**Planned Unit Development & Replat – Lot 19
Southport West and Lots 1, 2, and 3 Southport
West Replat Seven – Southport Parkway, LLC**

**CITY OF LA VISTA
PLANNING DIVISION
RECOMMENDATION REPORT**

CASE NUMBERS: PPUD21-0001;

Staff Review Letters

C3.1

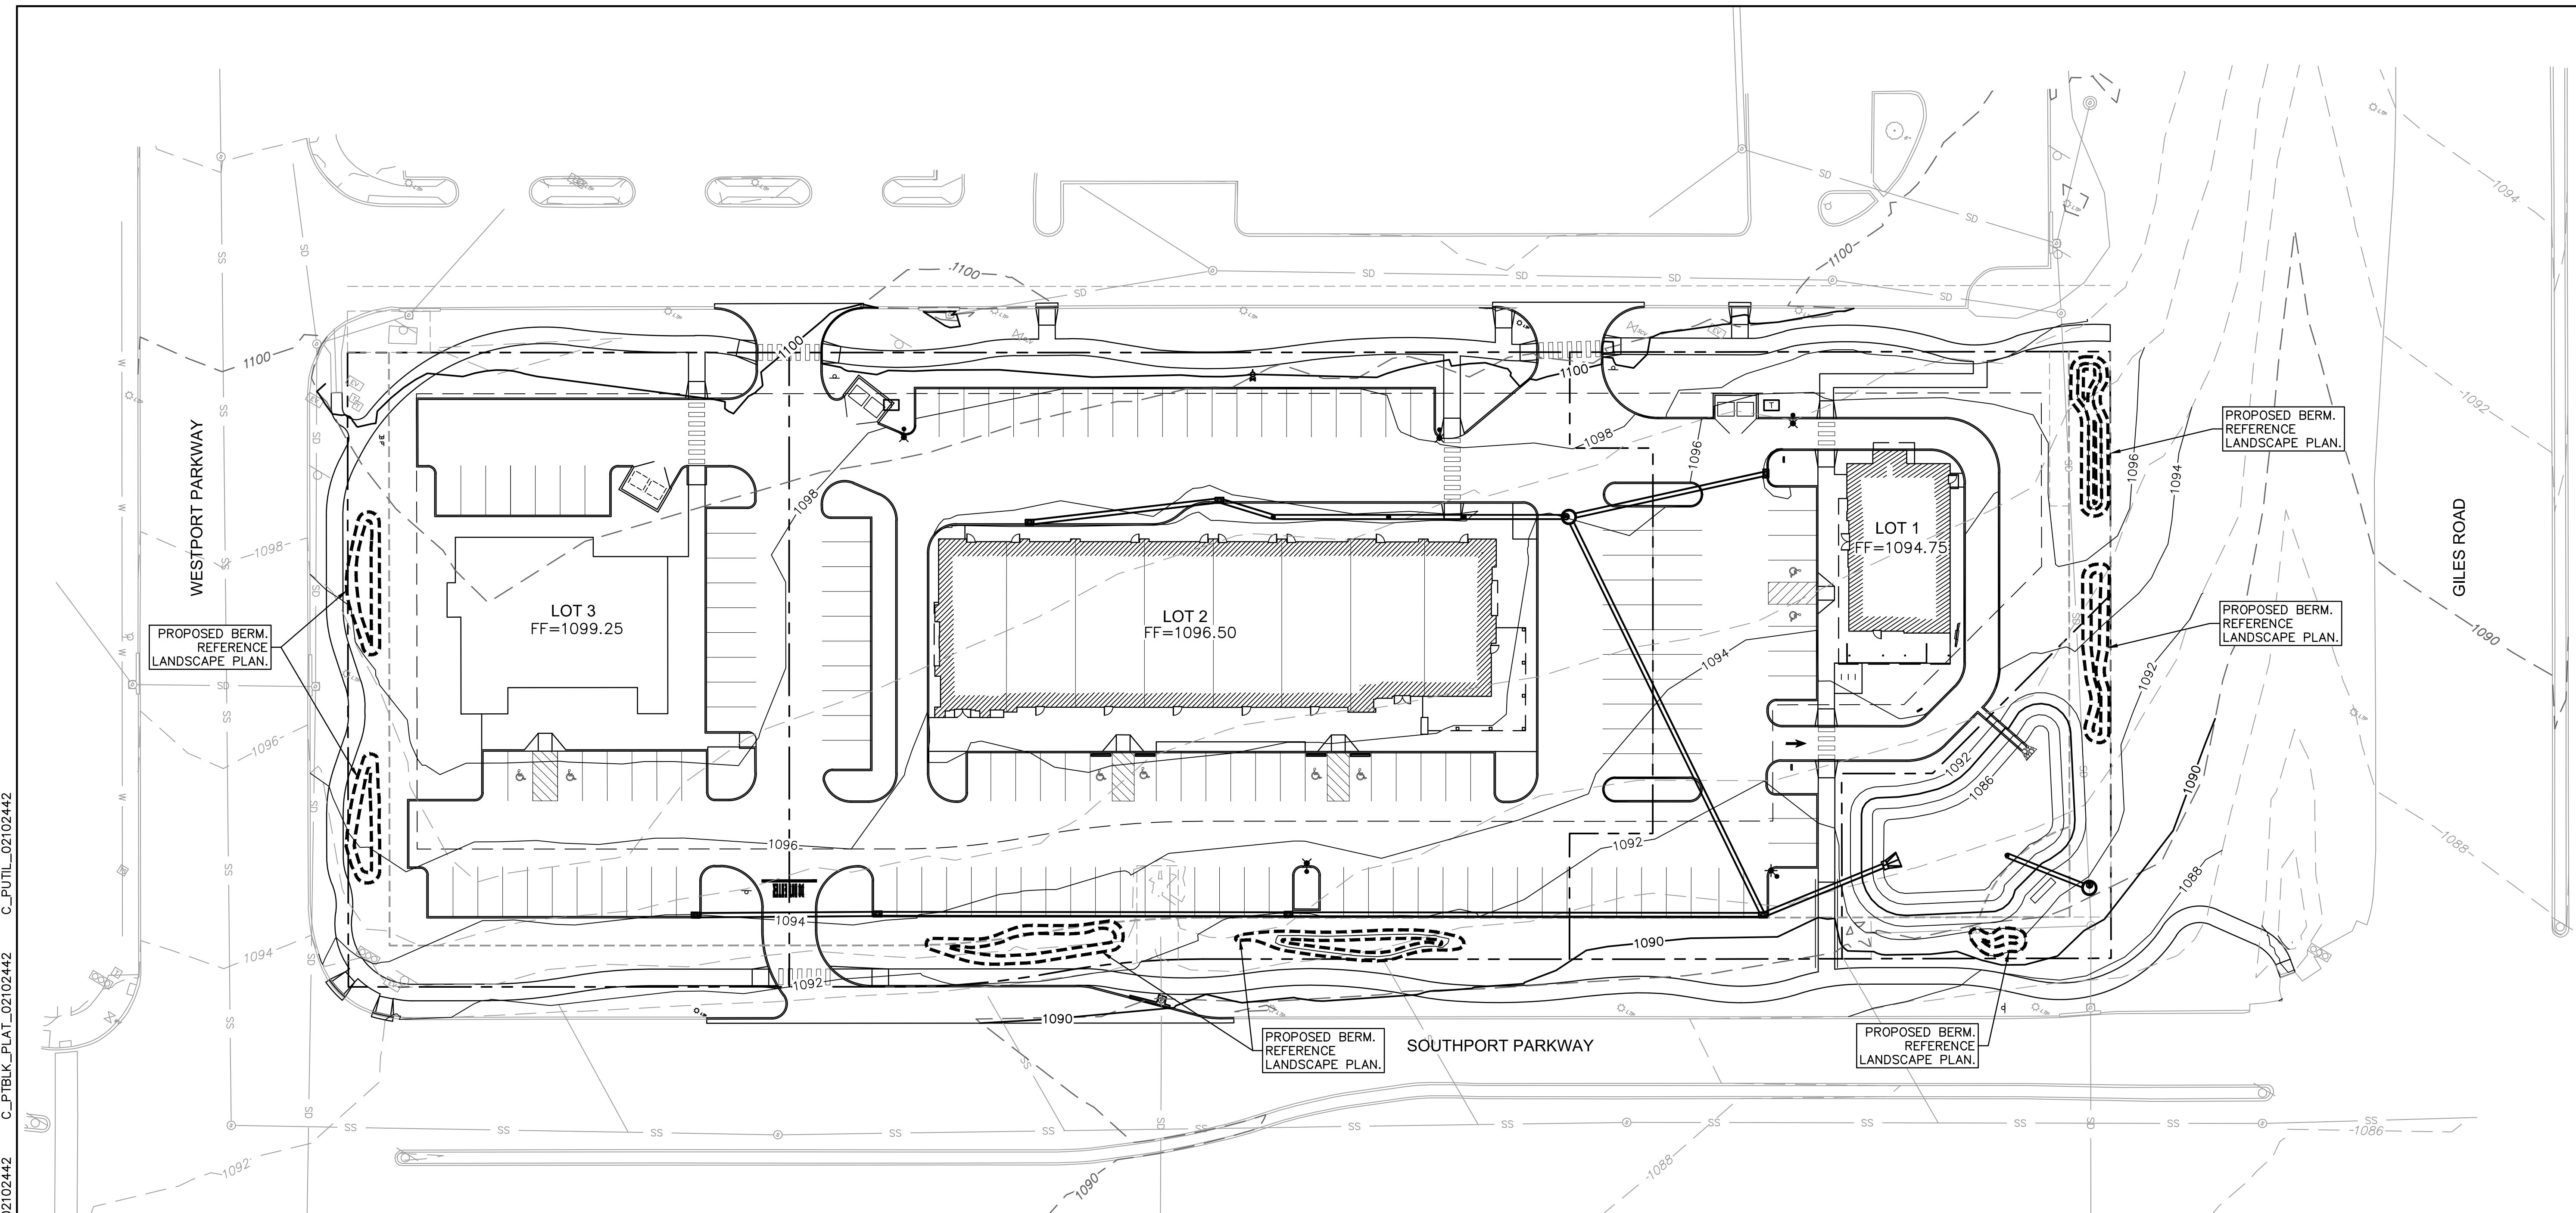
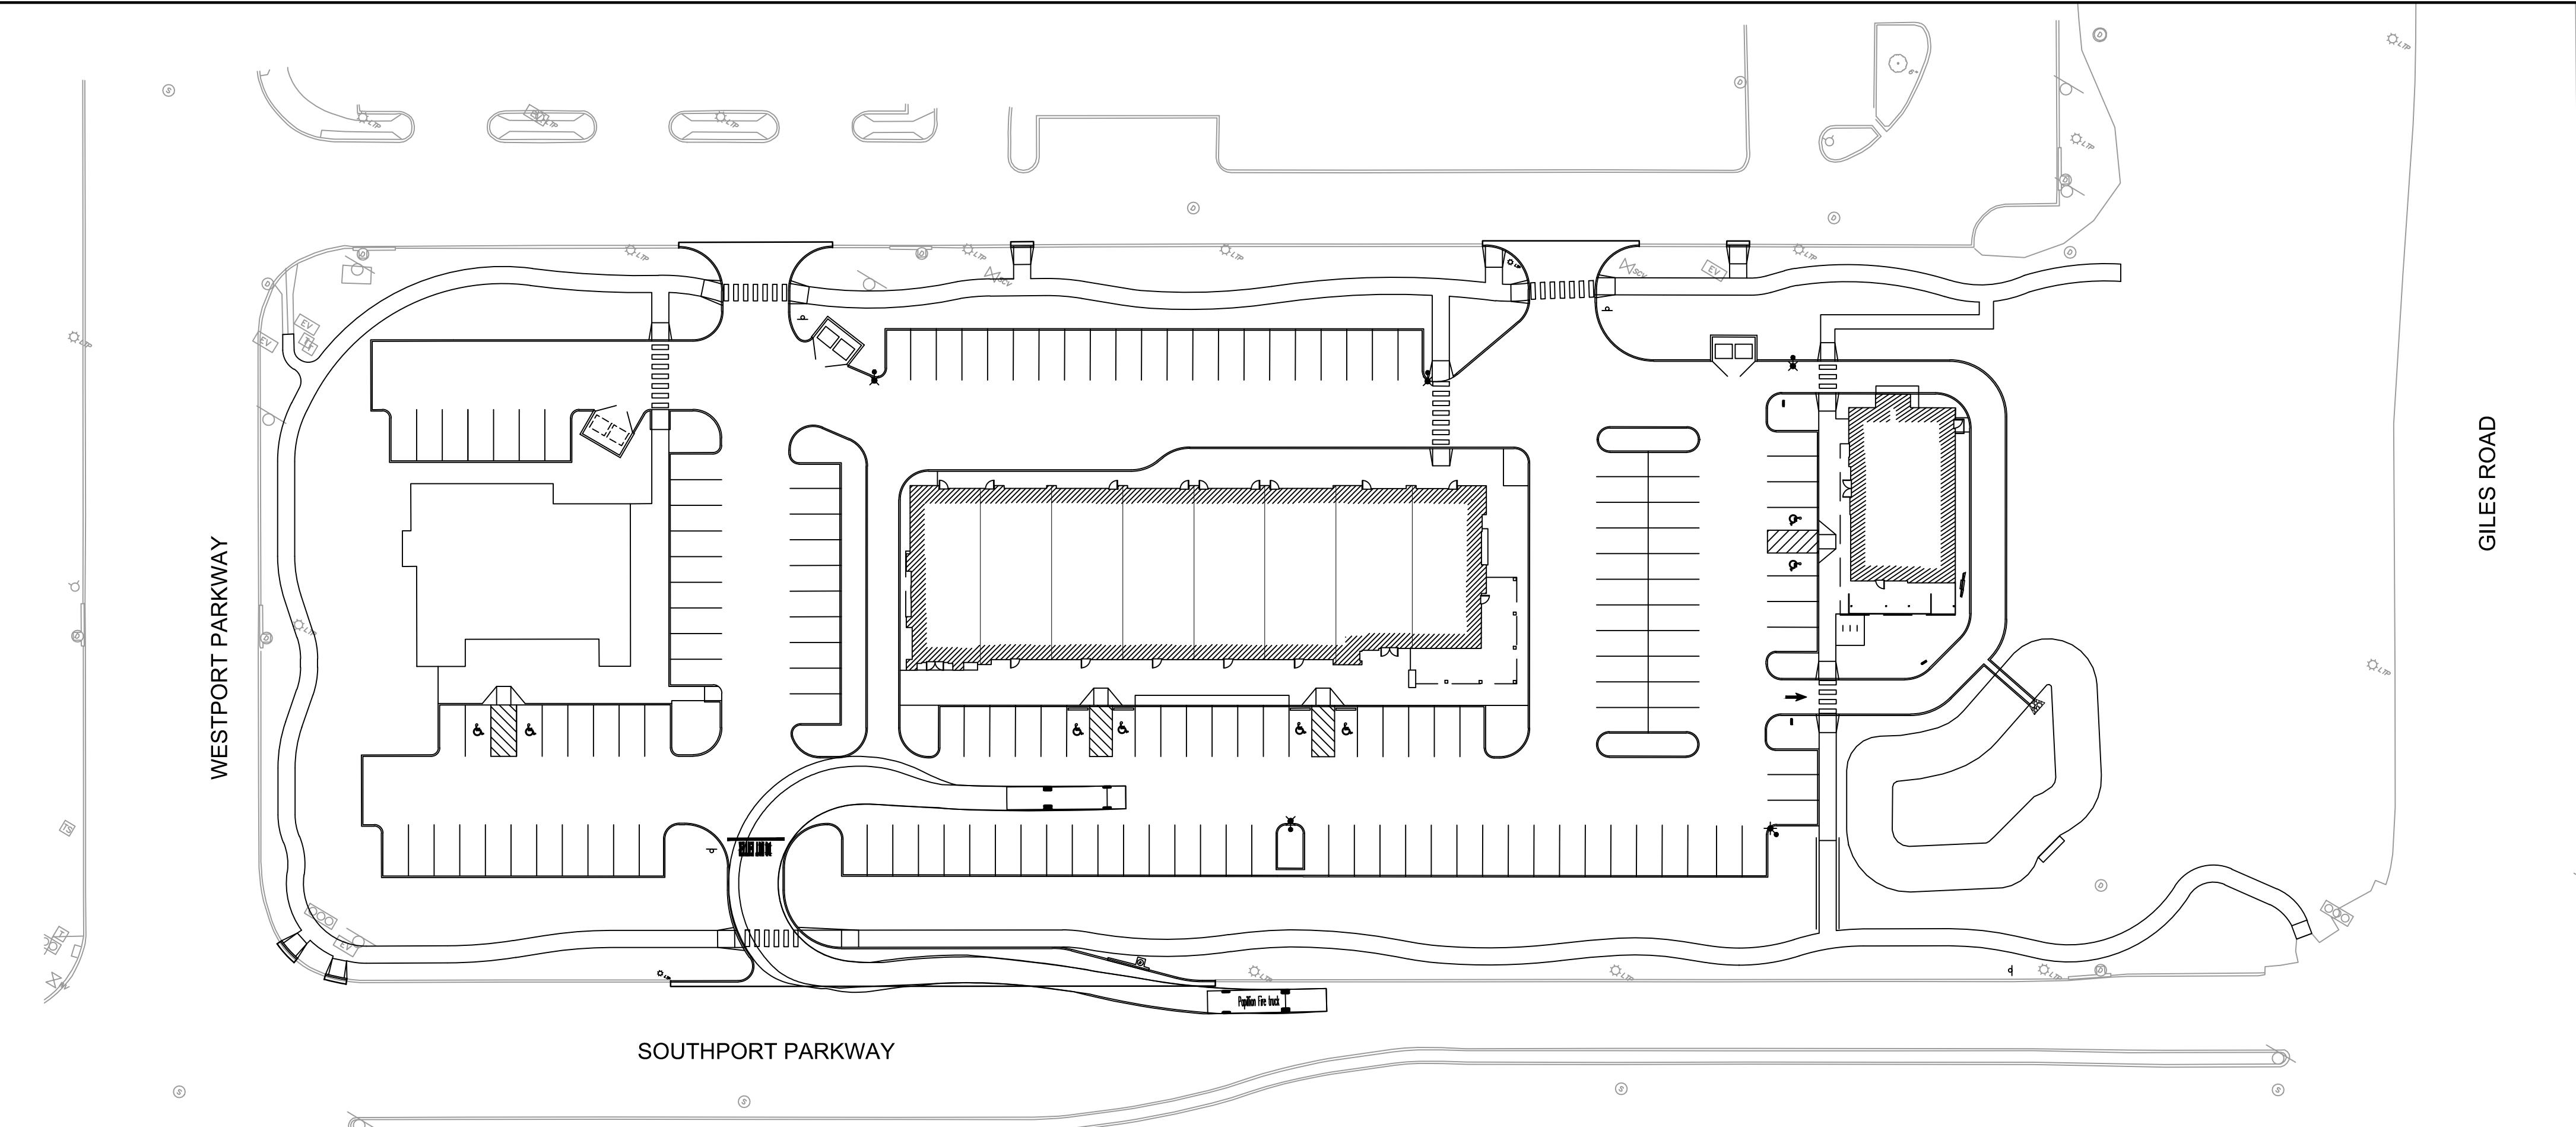
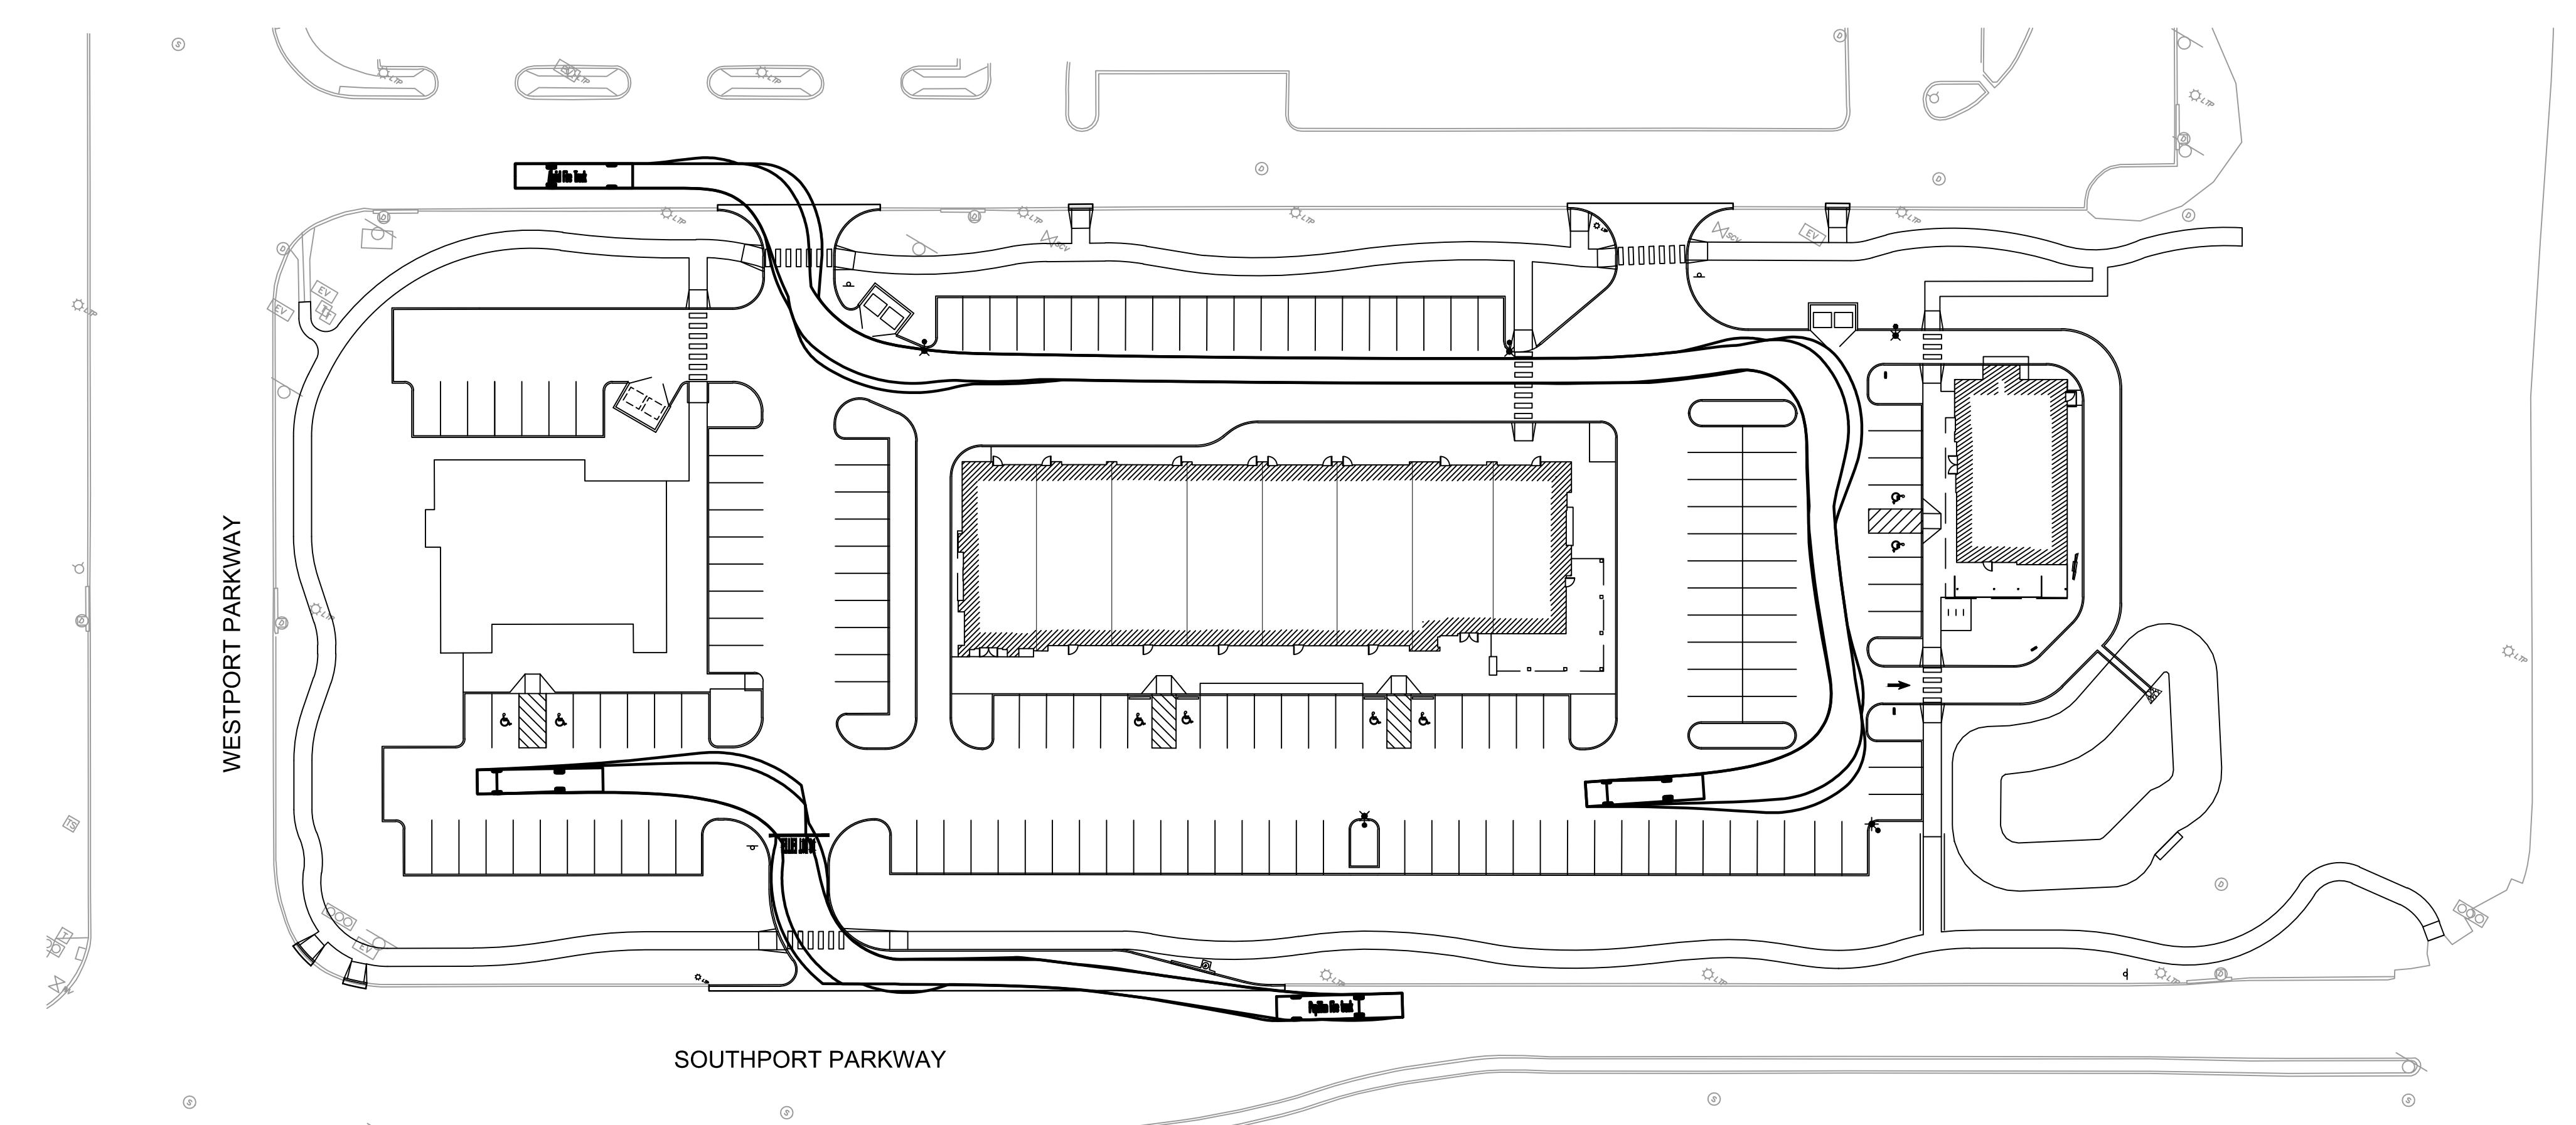
1. Grading work will require a grading permit. Please reach out to La Vista's Chief Building Official, Jeff Sinnett, at (402) 593-6400 for information on how to obtain your grading permit prior to the start of any grading.
2. As there are drainage capacity limitations at the culvert crossing near and under the rail road southeast of Giles road, all catchment drains that drain into said basin should be held to a no-net increase of the predevelopment flows until the drainage culverts at the railroad is up-sized to account for post-developed conditions for a 100-year return frequency.
